STAFF RECOMMENDATION 209 North 16th Street April 18, 2012

Application: Demolition, Infill
District: Lockeland Springs-East End Neighborhood Conservation Zoning Overlay
Council District: 06
Map and Parcel Number: 08310015200
Applicant: Jamie Pfeffer
Project Lead: Melissa Baldock, melissa.baldock@nashville.gov

Description of Project: Demolish non-contributing house and construct a new single-family residence.

A1.0

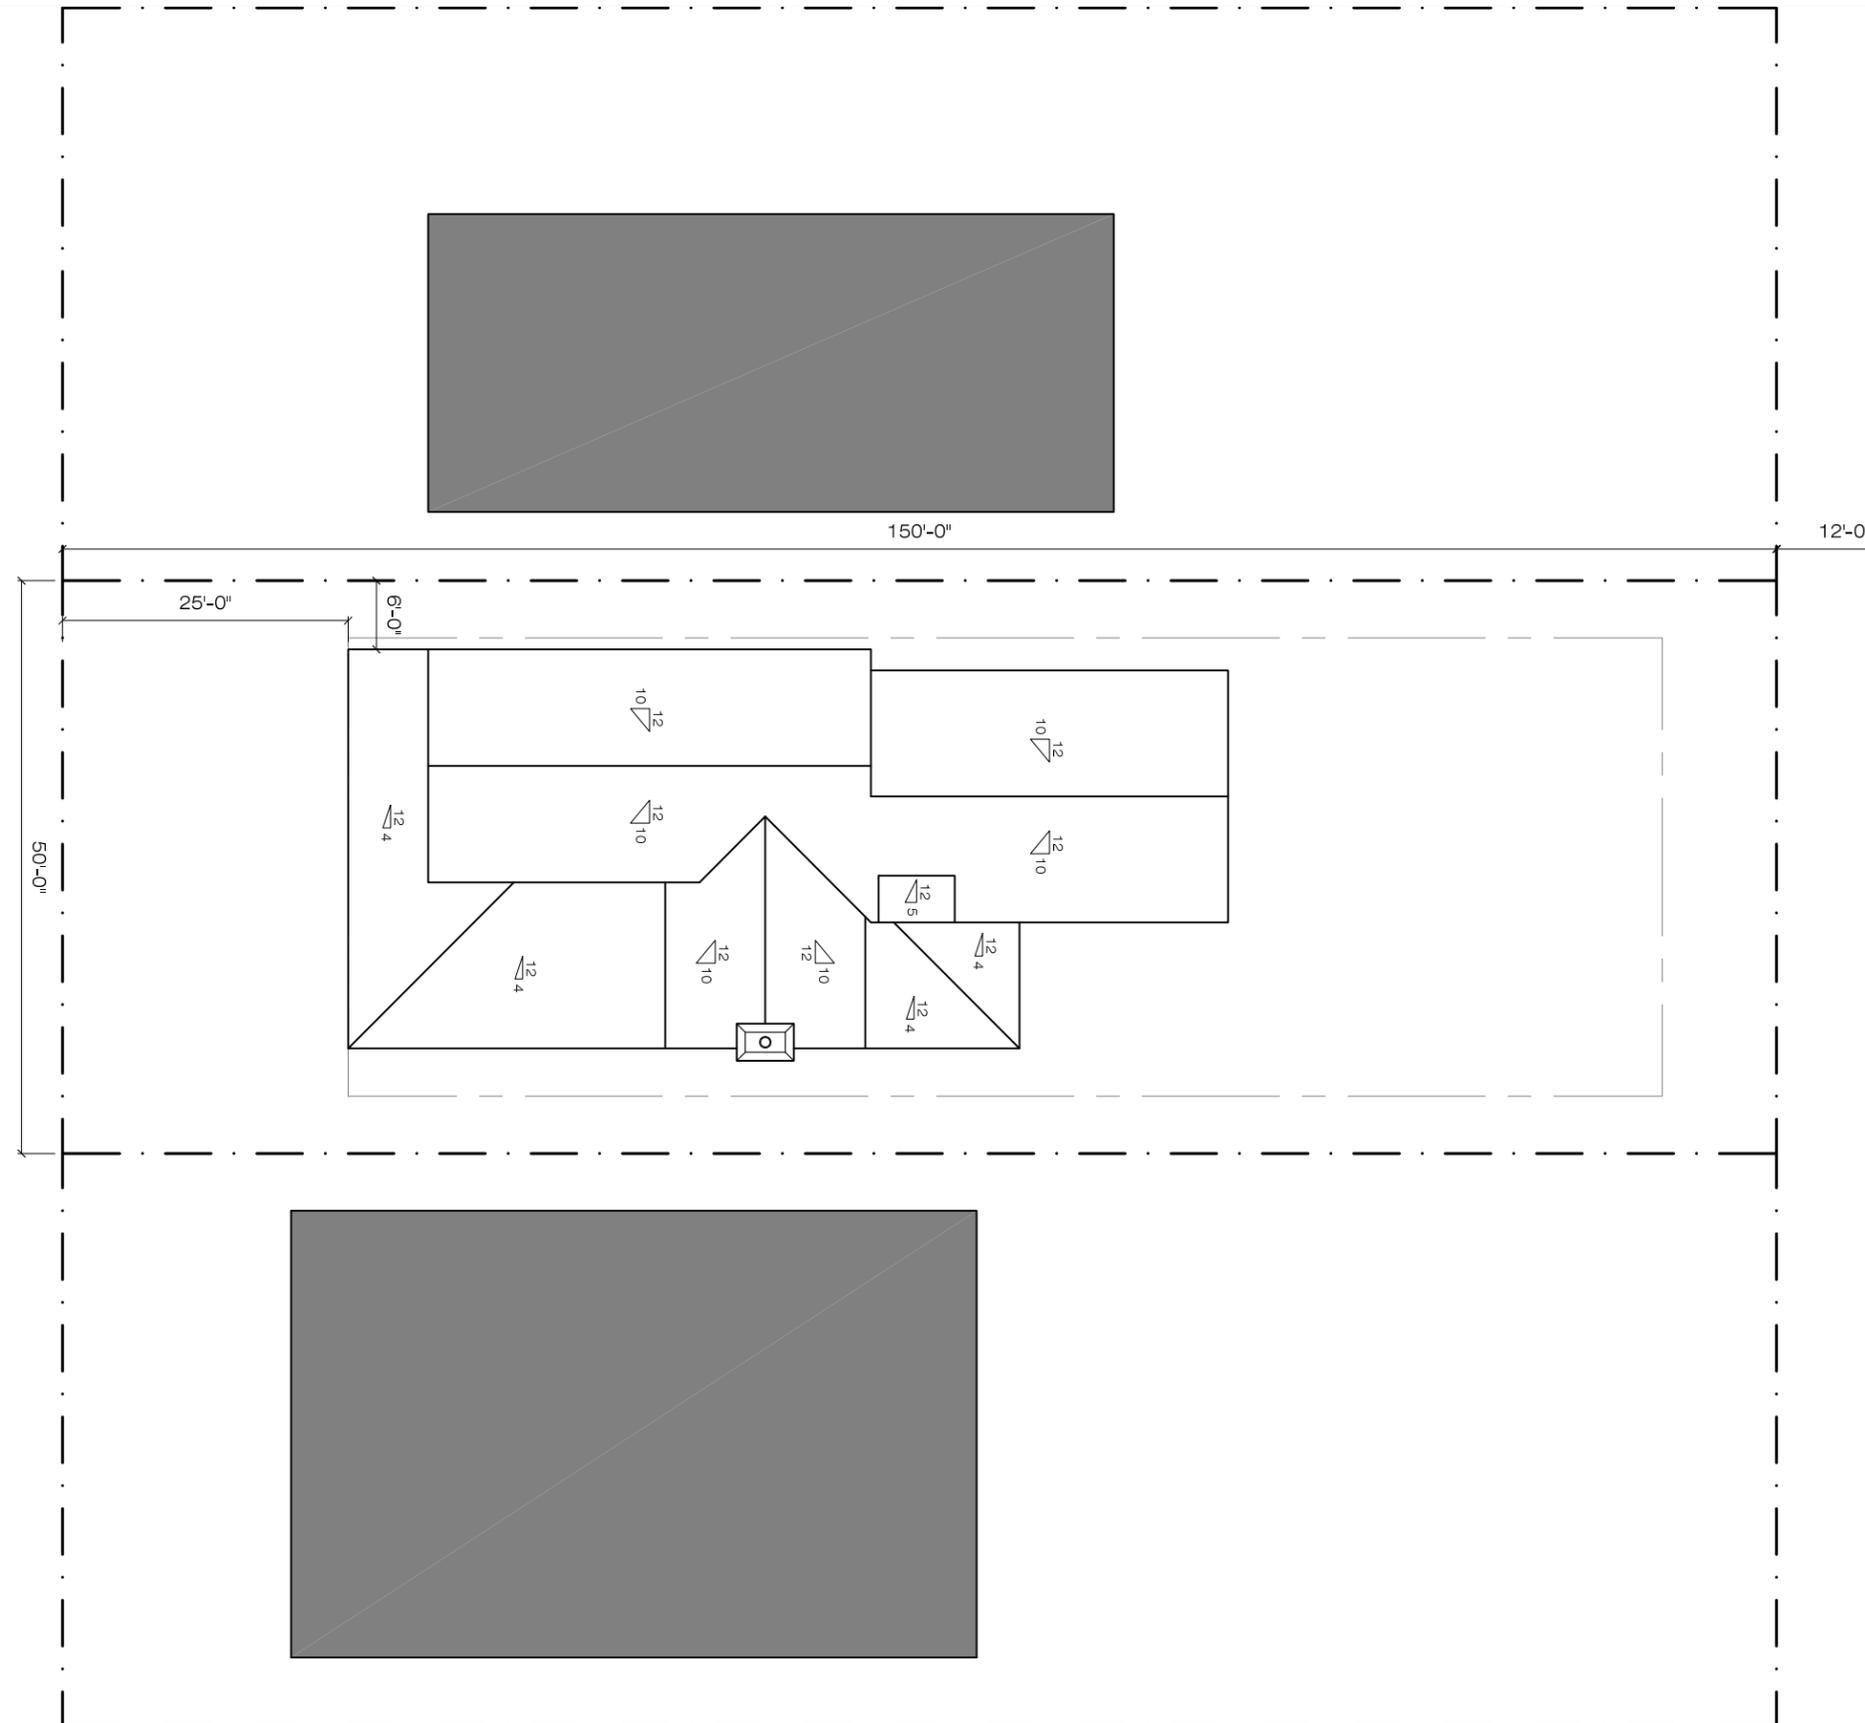
Setback and Rhythm of Spacing: The proposal meets all bulk zoning setback requirements. The structure will be sited slightly off-center on the lot, towards the left/north. In the immediate vicinity, the historic structures vary from being centered on the lot to being sited slightly off-center like the new infill. The proposed structure will be set back approximately twenty-five feet (25') from the front property line. By comparison, the historic house to the right, 207 North 16th Street, is set twenty-feet (20') from the front property line. The additional inset of five feet (5') will help mitigate the infill's height and represents the approximate average of setbacks in the immediate vicinity.

1 MAIN LEVEL PLAN
SCALE 1/8" = 1'-0"

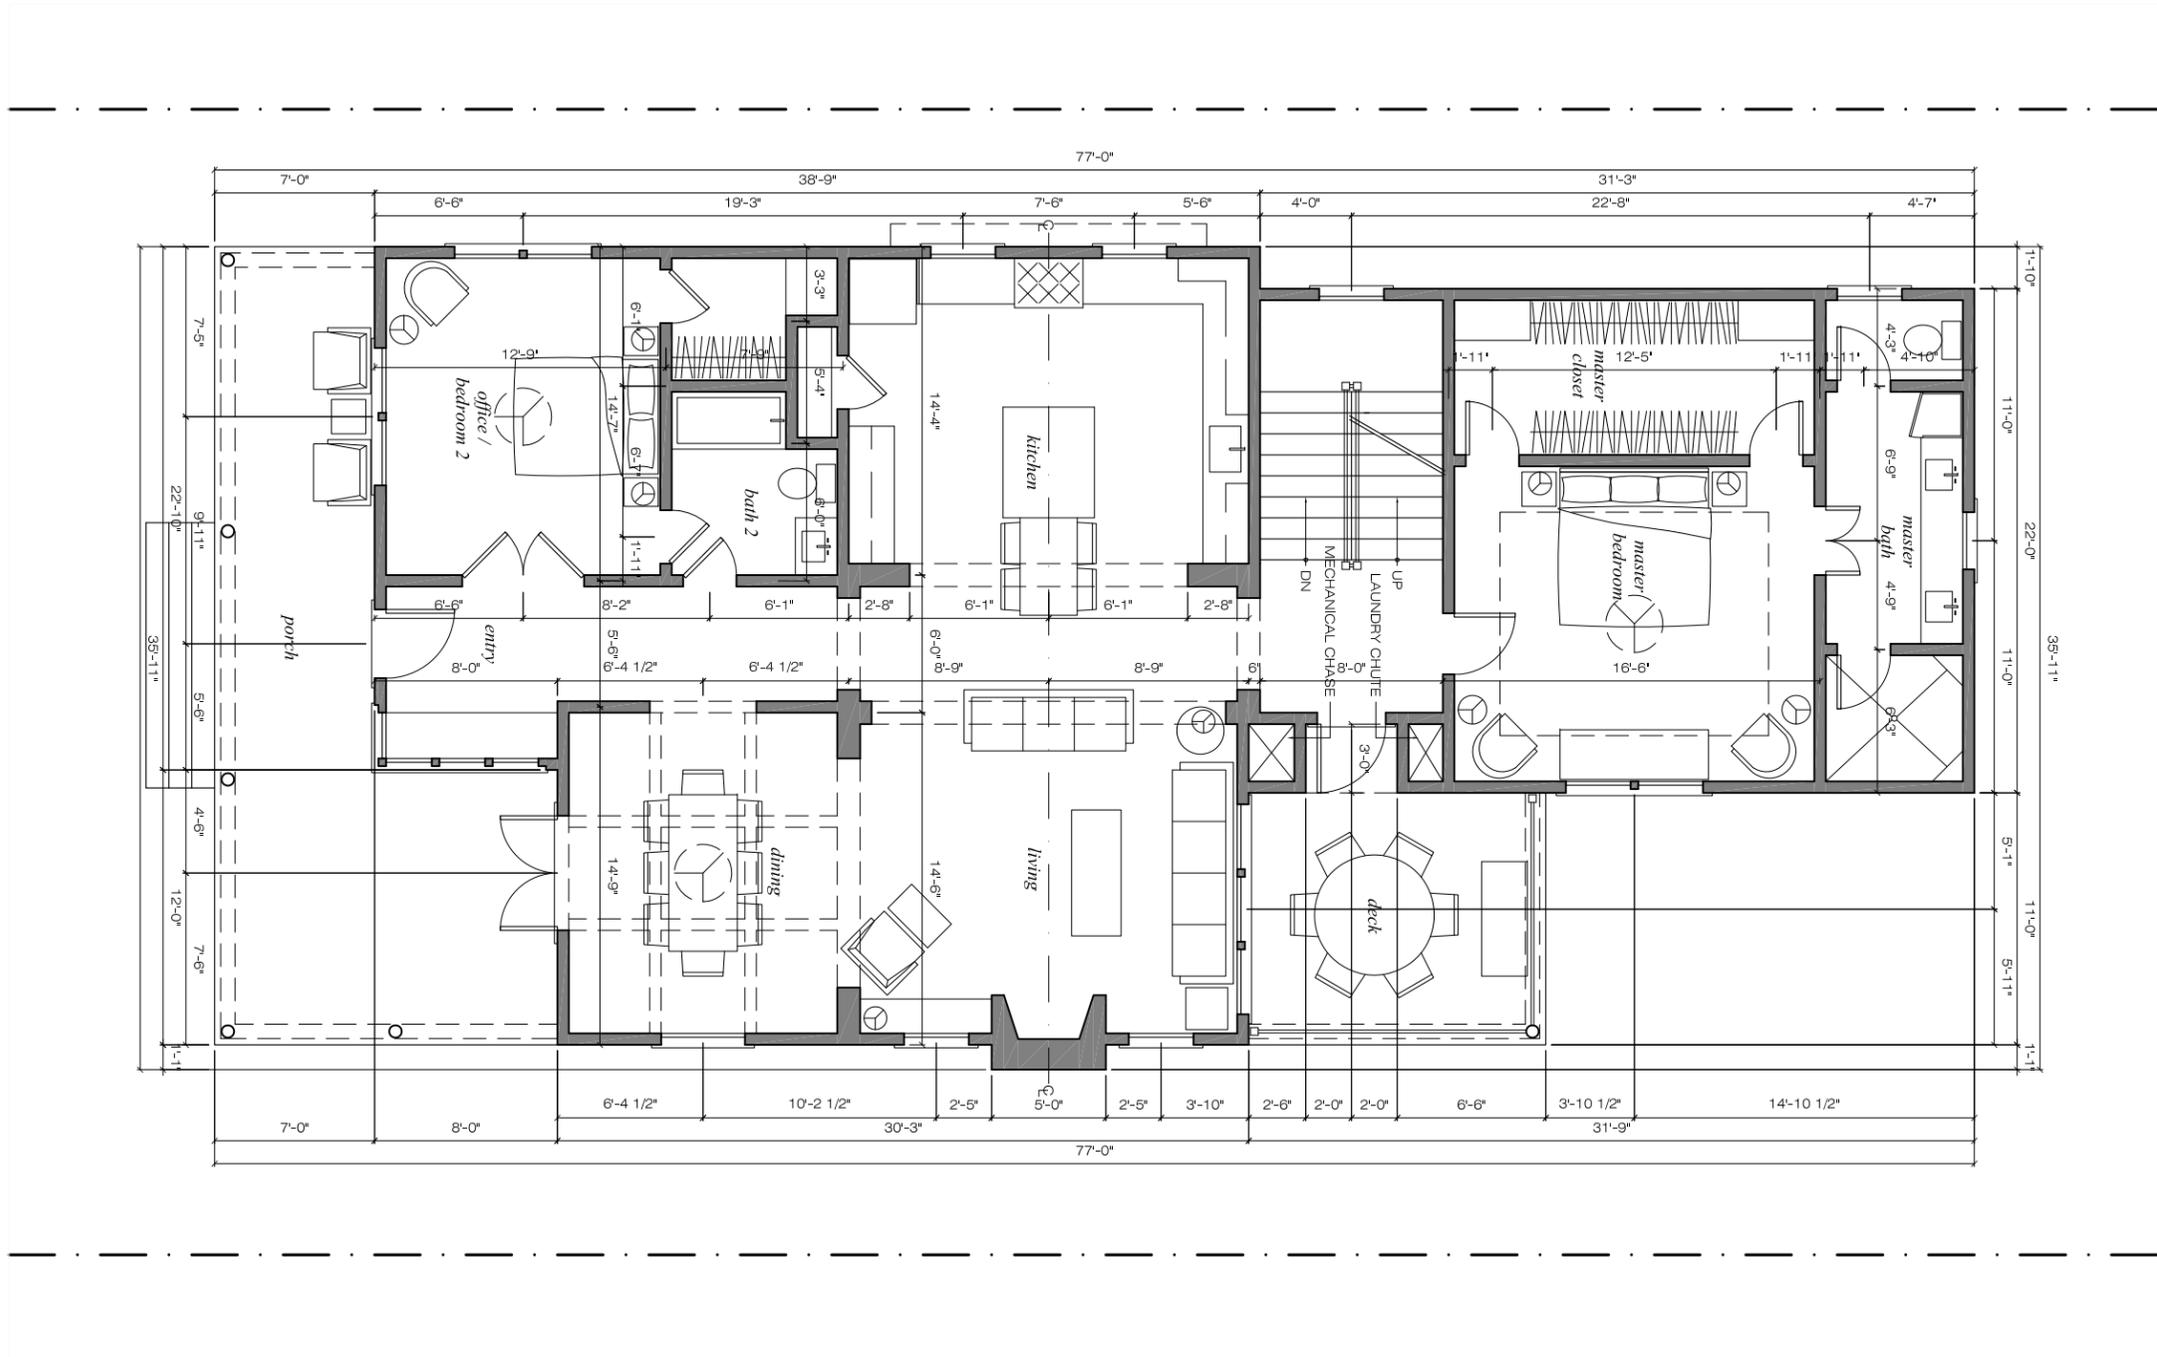
Outbuildings: The applicant is proposing an attached garage at the rear of the building. The garage will be accessed from the alley. Staff finds the proposed attached garage to meet the design guidelines in this instance because it is located towards the rear of the property where garages typically would have been placed and because its garage doors will be on the rear façade and will not be visible from the street. In addition, because of the slope of the site, the garage will be located at the basement level, below the grade of the front of the house.
